ADDENDEUM TO NEGATIVE DECLARATION  
(14 CCR 15164)  
Kern County Water Agency

Project: Pioneer Groundwater Recharge and Recovery (SCH# 96111037)  
Lead Agency: Kern County Water Agency (KCWA)  
Location: Located in Section 3,4,11, & 14 T30/R26, MDBM, just west of the intersection of Allen Rd and Ming Ave Extensions, west of CSUB.

**PIONEER PROJECT**  
**KCWA/CASTLE & COOKE/BOLTHOUSE LAND EXCHANGE**  
 DECEMBER 1, 2003

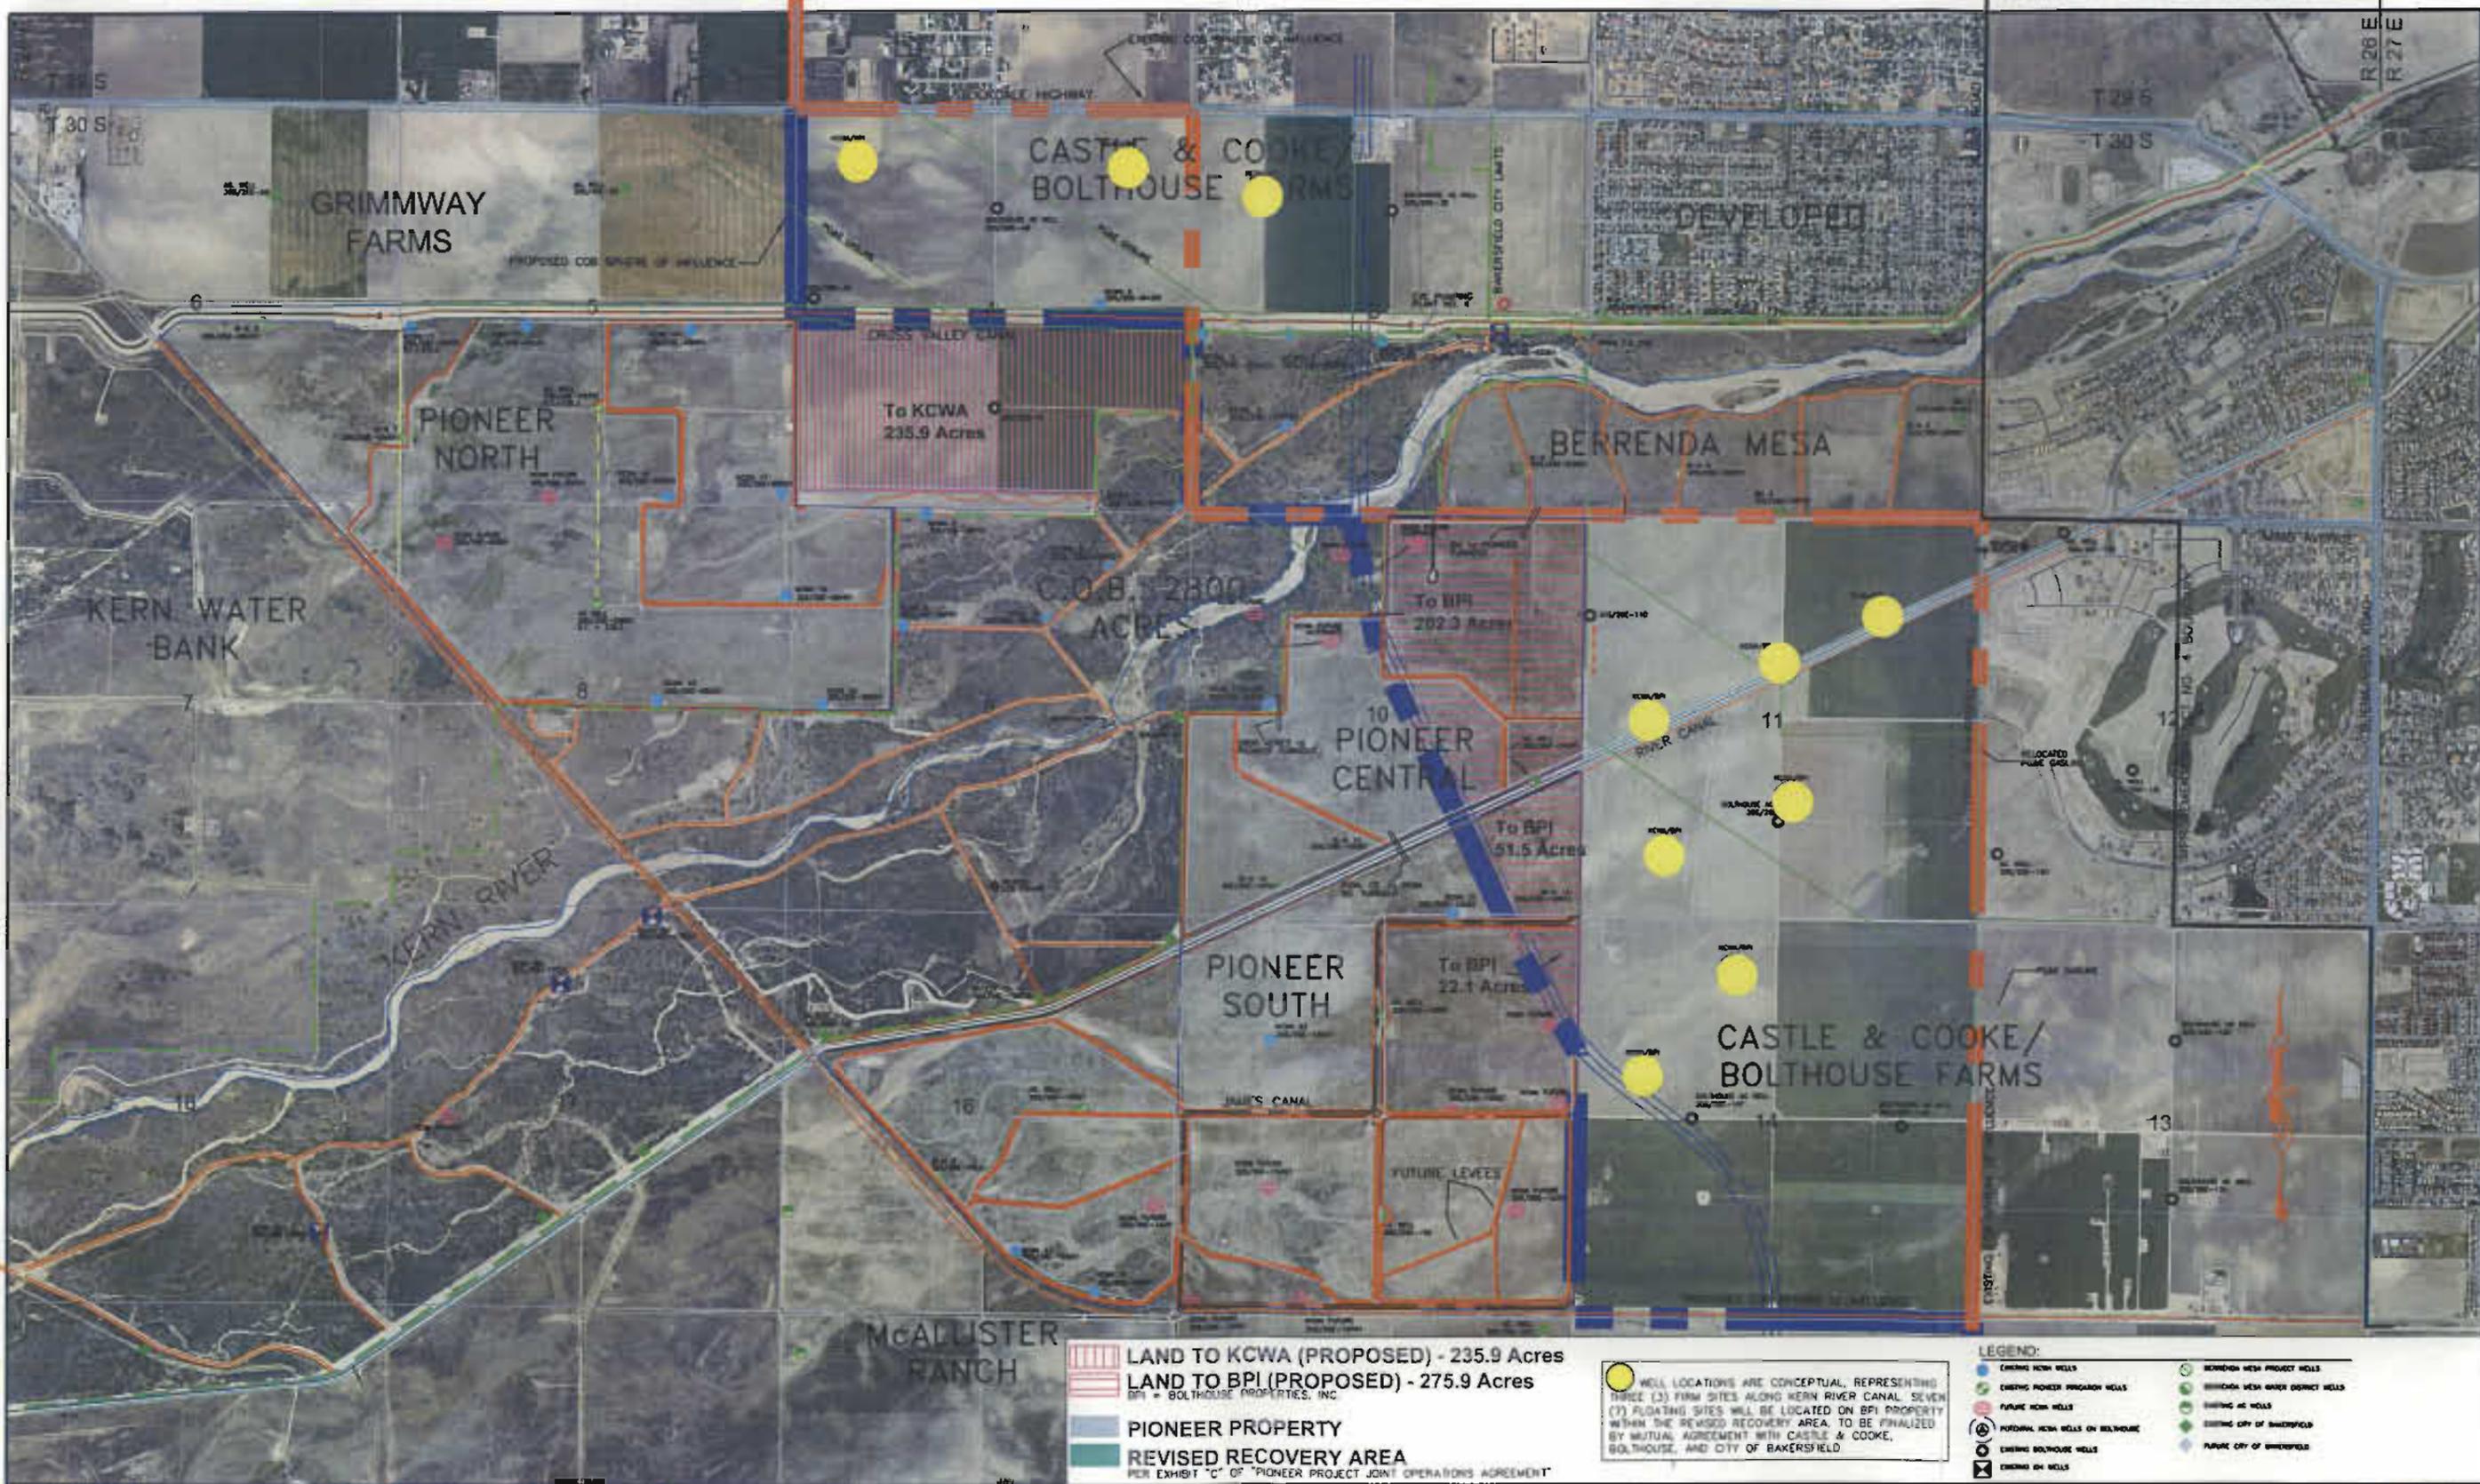
The proposed change to the Negative Declaration involves moving the location of well sites from the Pioneer property approximately one mile east in order to accommodate a land exchange and to spread out the well field which will lessen the impacts to groundwater levels and drawdown effects compared to the original well site locations. The same amount of water will be pumped on the new well sites as the original well sites. No increase in biological impacts will occur because the revised well sites are located on actively farmed lands. The lands have been re-zoned for residential development and are located within the Metropolitan Bakersfield Habitat Conservation Plan which permits and mitigates for urban development on prior agricultural lands. As such there is no material difference in the project with the change in well site location as compared to the Negative Declaration.

LAND TO KCWA (PROPOSED) - 235.9 Acres  
 LAND TO BPI (PROPOSED) - 275.9 Acres  
 BPI = BOLTHOUSE PROPERTIES, INC.  
 PIONEER PROPERTY  
 REVISED RECOVERY AREA  
 PER EXHIBIT "C" OF "PIONEER PROJECT JOINT OPERATIONS AGREEMENT"

WELL LOCATIONS ARE CONCEPTUAL, REPRESENTING THREE (3) FIRM SITES ALONG KERN RIVER CANAL SEVEN (7) FLOATING SITES WILL BE LOCATED ON BPI PROPERTY WITHIN THE REVISED RECOVERY AREA, TO BE FINALIZED BY MUTUAL AGREEMENT WITH CASTLE & COOKE, BOLTHOUSE, AND CITY OF BAKERSFIELD
